APPEAL SUMMARY

Appeal ID: 14939	Project Address: 118 NE 16th Ave
Hearing Date: 4/12/17	Appellant Name: Matthew Kirkpatrick
Case No.: B-007	Appellant Phone: 503-239-1987
Appeal Type: Building	Plans Examiner/Inspector: Marc Vieno
Project Type: commercial	Stories: 4 Occupancy: R-2 Construction Type: V-A
Building/Business Name:	Fire Sprinklers: Yes - throughout
Appeal Involves: Erection of a new structure	LUR or Permit Application No.: 17-102113-CO
Plan Submitted Option: pdf [File 1]	Proposed use: multifamily

APPEAL INFORMATION SHEET

A1

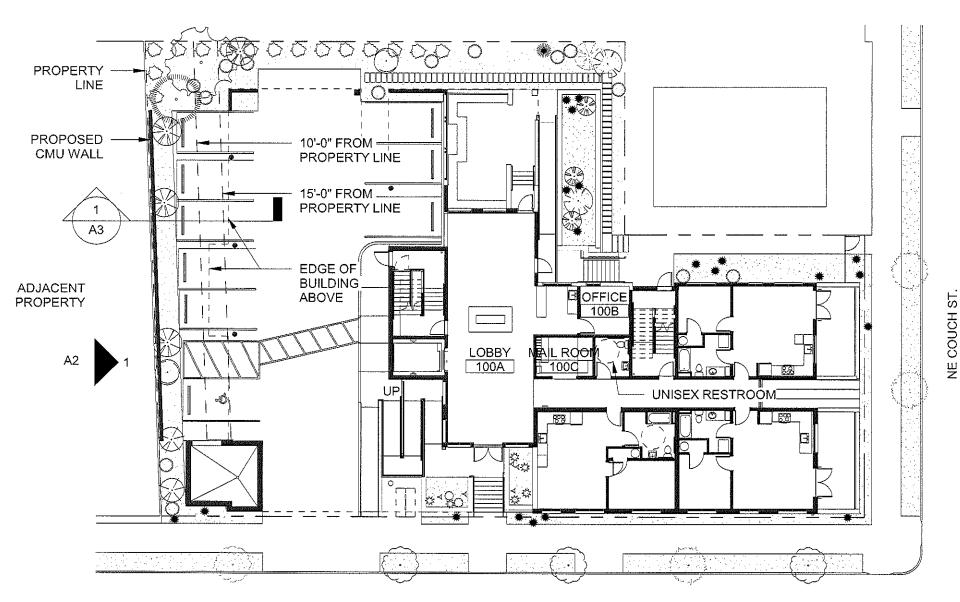
automatic sprinkler system in accordance with Section 903.3.1.1. Section 903.3.1.1 requires NFPA 13 sprinklers.
Proposed Design	Construct a detached 8" concrete masonry wall against the property line to the north running the length of the parking area (see attached site plan and elevation), and provide NFPA-13R sprinklers throughout.
Reason for alternative	We believe this proposed configuration meets code requirements, however during our preliminary life safety meeting, our plans examiner felt that he would like to see this processed through an appeal due to the nature of this wall being detached from the primary structure
	Per table 721.1(2), an 8" concrete masonry unit wall provides four hour protection which exceeds the one hour requirement specified in table 602. The covered parking area is 11'-0" from the property line at its closest, and 16'-7" at its furthest. By building a concrete masonry wall near the property line that covers the extents of the opening, the open area projected against the property line is 0% of the wall area along the first floor.

2. Eight inch c.m.u. wall at property line to allow unlimited openings at the North Elevation at garge level: Granted provided wall height is at least as high as the openings.

1 NORTH ELEVATION WITH PROPOSED WALL 1/16" = 1'-0"

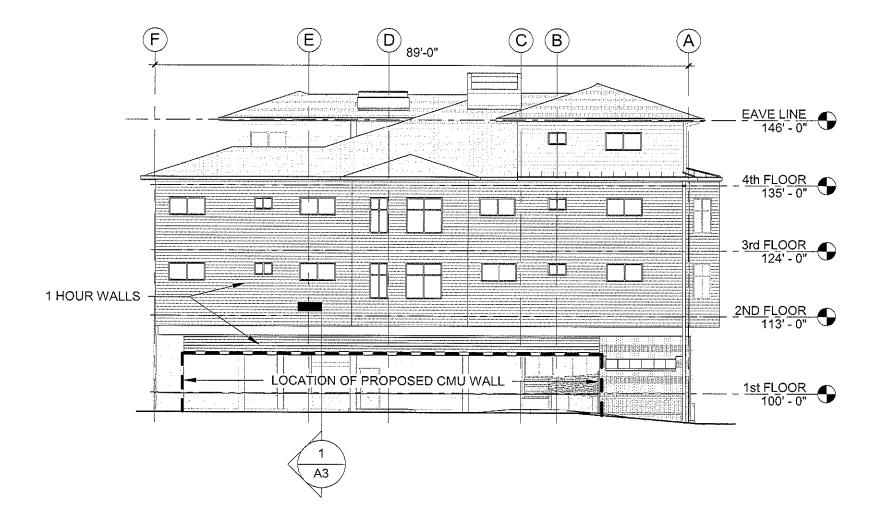
Appeal item 2	
Code Section	705.8 Openings
Requires	"The maximum area of unprotected and protected openings permitted in an exterior wall in any
	story of a building shall not exceed the percentages specified in Table 705.8"
	Per table 705.8, a fire separation distance of 10'-0" to 15'-0" allows 15% unprotected,
	nonsprinklered openings and 45% protected or sprinklered openings. A fire separation distance of
	15'-0" to 20'-0" allows 25% unprotected, nonsprinklered openings and 75% protected or
	sprinklered openings. For this table, sprinklered is defined as "equippedthroughout with an
